SERVICE LETTER NO. SL-112-46
Revision No. 1
27 October 1981

ELEVATOR AND RUDDER HINGE FITTING INSPECTION AND/OR REPLACEMENT

SERVICE LETTER NO. SL-112-46
14 November 1979

REASON FOR PUBLICATION: POSSIBLE ELONGATION OF HOLES IN HINGE FITTINGS AND CRACKS IN RUDDER SPAR.

Figure 1.

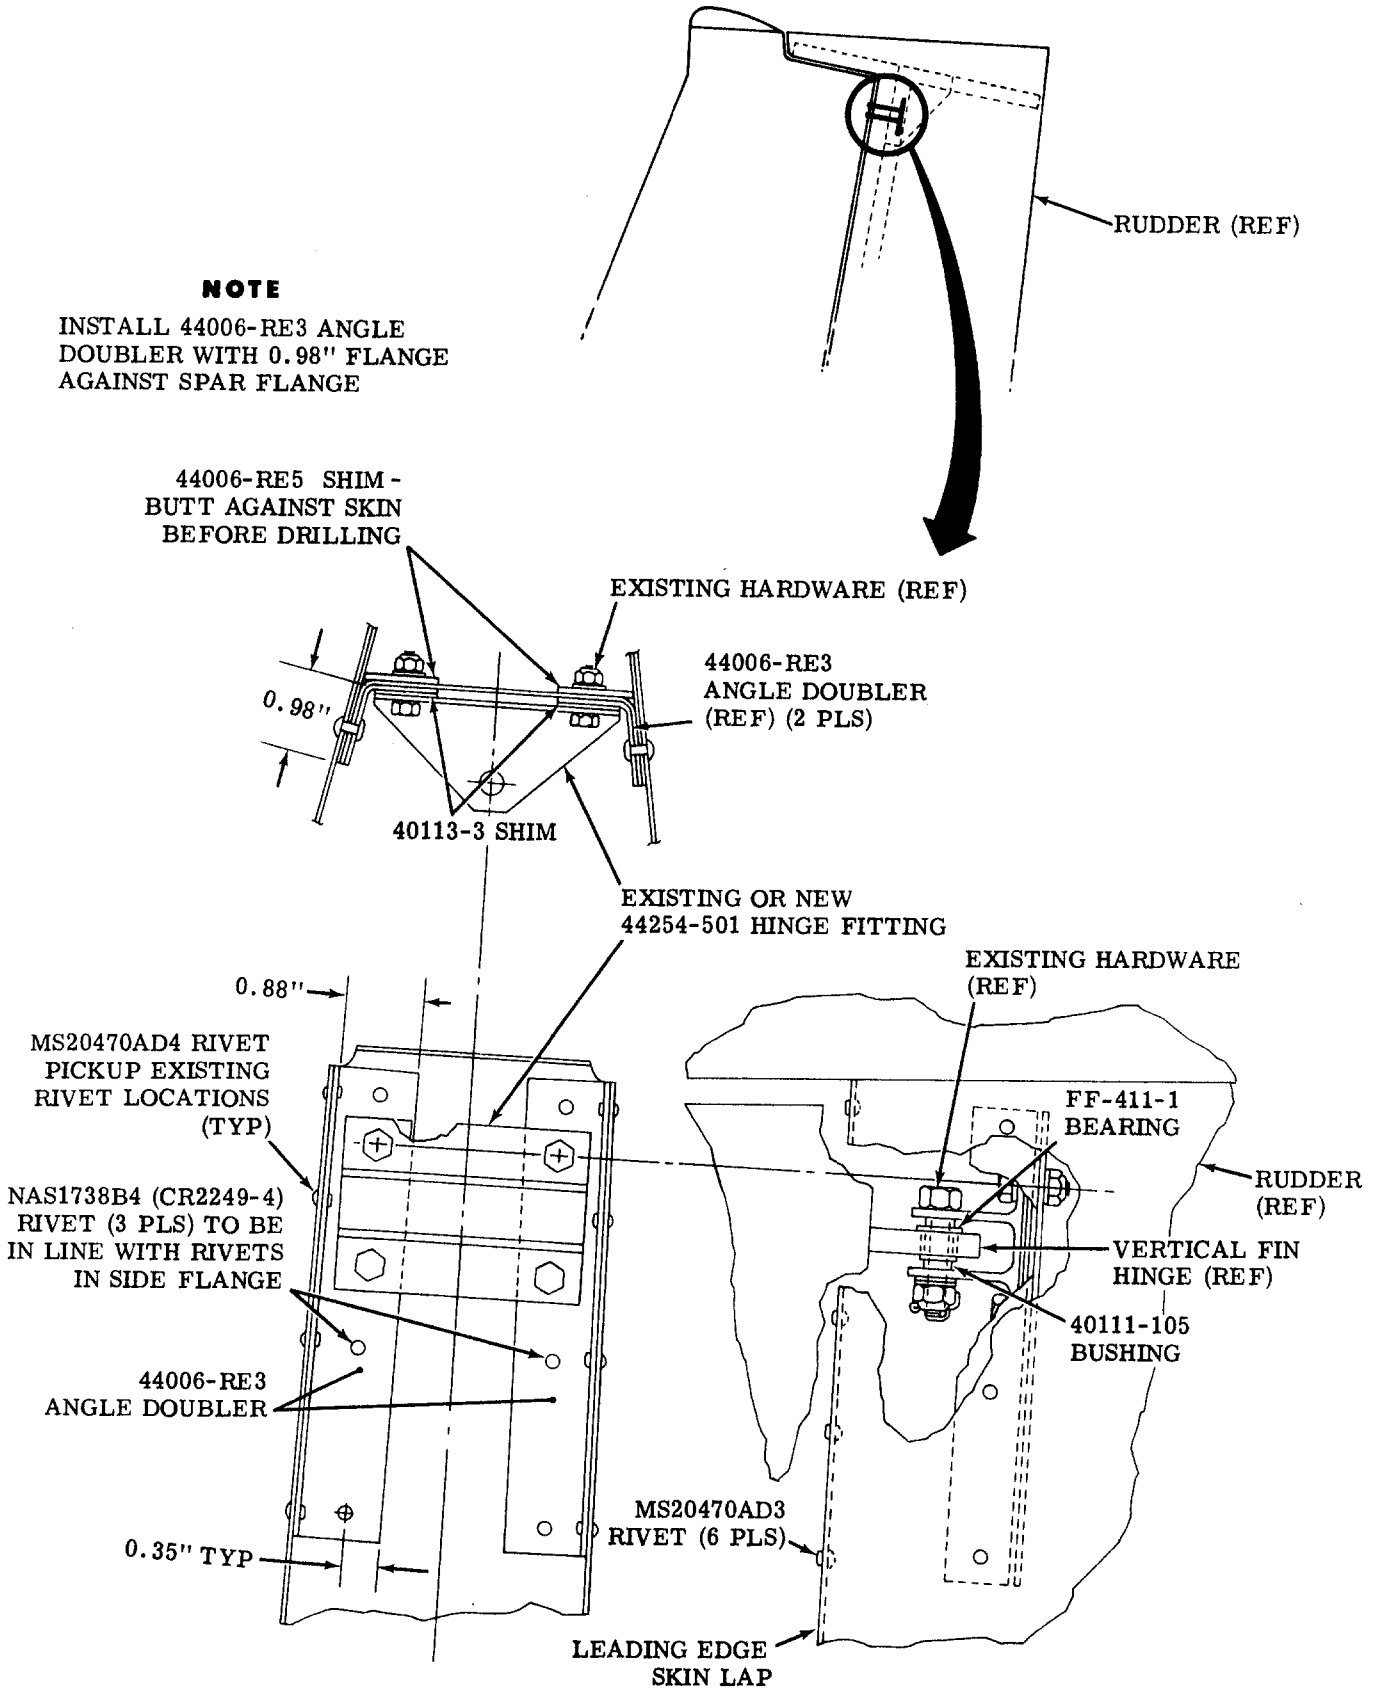
- b. Remove upper six (6) rivets from rudder assembly leading edge skin lap.
 - c. Stop drill all cracks with a No. 40 (0.098) diameter drill.
 - d. Locate, drill and install 44006-RE3 angle doubler (2 places) on rudder assembly (see Figure 1.).

- e. If existing hinge fitting is to be used, trim 0.06-inch to 0.07-inch from each end of existing hinge fitting.
 - f. Install existing or new 44254-501 hinge fitting, 44006-RE5 shim (2 places) and 40113-3 shim (2 places) using existing hardware (see Figure 1.).

10. Reinstall tip on rudder assembly.
11. Remove and discard existing oilite bearing from upper vertical fin hinge.
12. Install FF-411-1 bearing in upper vertical fin hinge and ream hole in new bearing to 0.317/0.318-inch (see Figure 1.).

Figure 2.

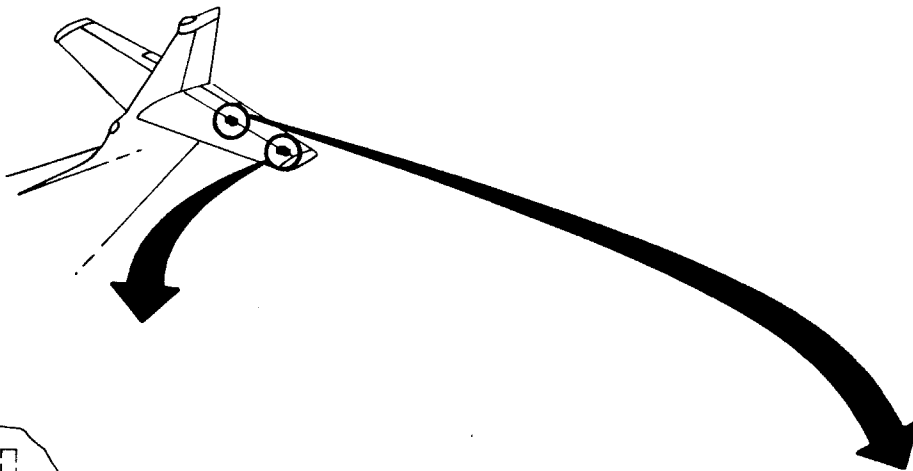
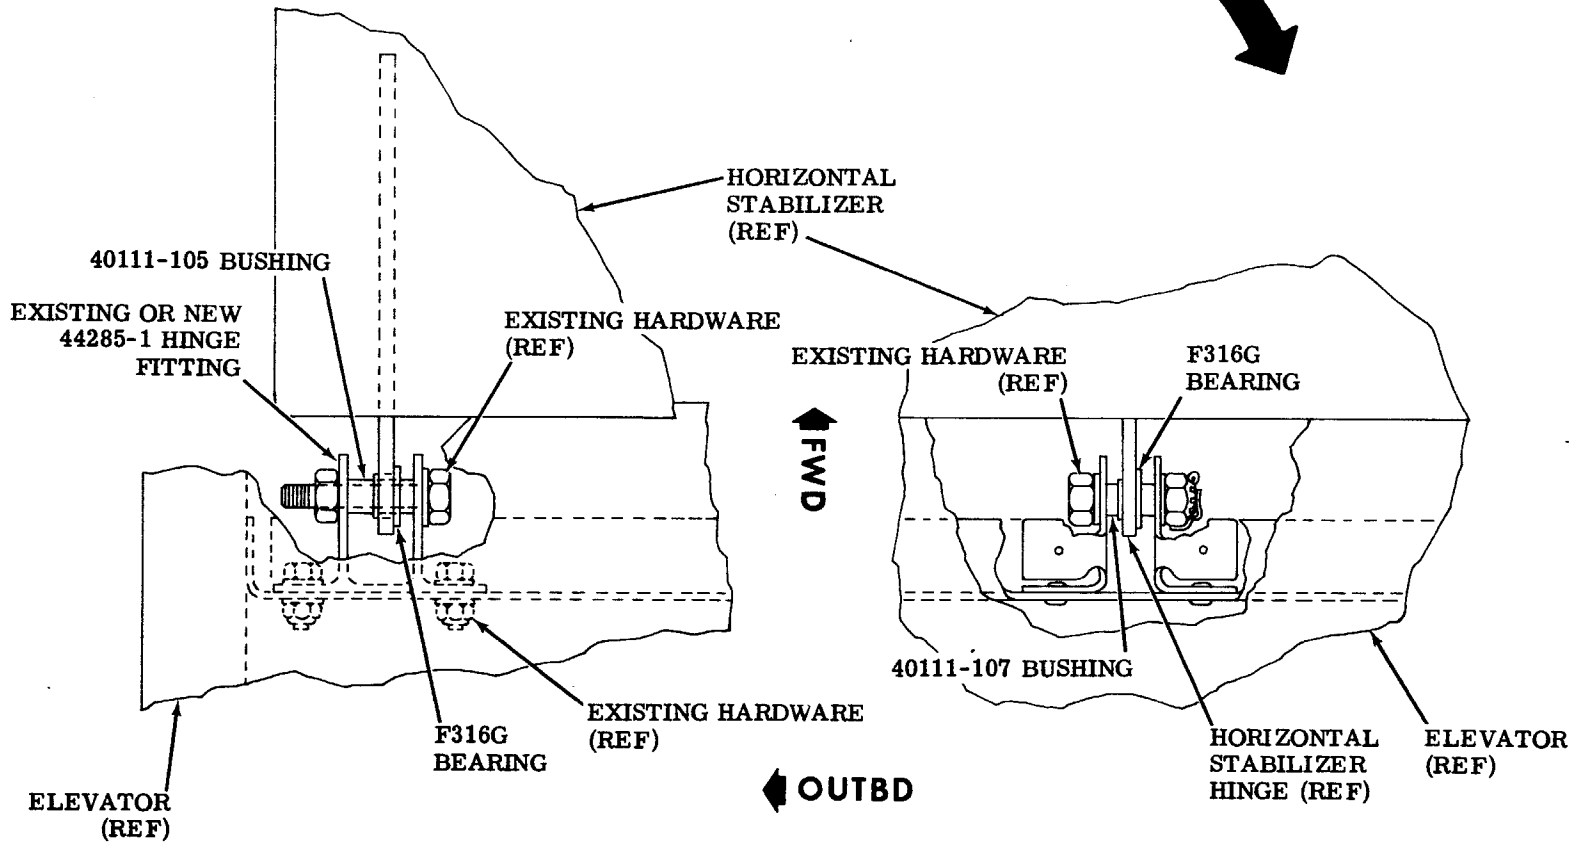
- d. Install new 44285-1 hinge fitting on elevator using existing hardware (see Figure 2.).
 - e. Attach skin to elevator structure using MS20426AD4 rivets and NAS1738B4 blind rivets.
 - f. Repaint elevator surfaces as necessary.
 - g. Reinstall tip on elevator.
18. Remove and discard existing oilite bearings from horizontal stabilizer center and outboard hinges.
 19. Install F316G bearing (4 places) on horizontal stabilizer center and outboard hinges and ream hole in bearings to 0.317/0.318-inch (see Figure 2.).
 20. Reinstall rudder assembly on airplane as outlined in the Airplane Maintenance Manual, Section VII, using existing hardware and 40111-105 bushing (see Figure 1.).

21. Reinstall left and right elevator assemblies on airplane as outlined in the Airplane Maintenance Manual, Section VII, using existing hardware, 40111-107 bushing (center hinge) and 40111-105 bushing (outboard hinge) (see Figure 2.).
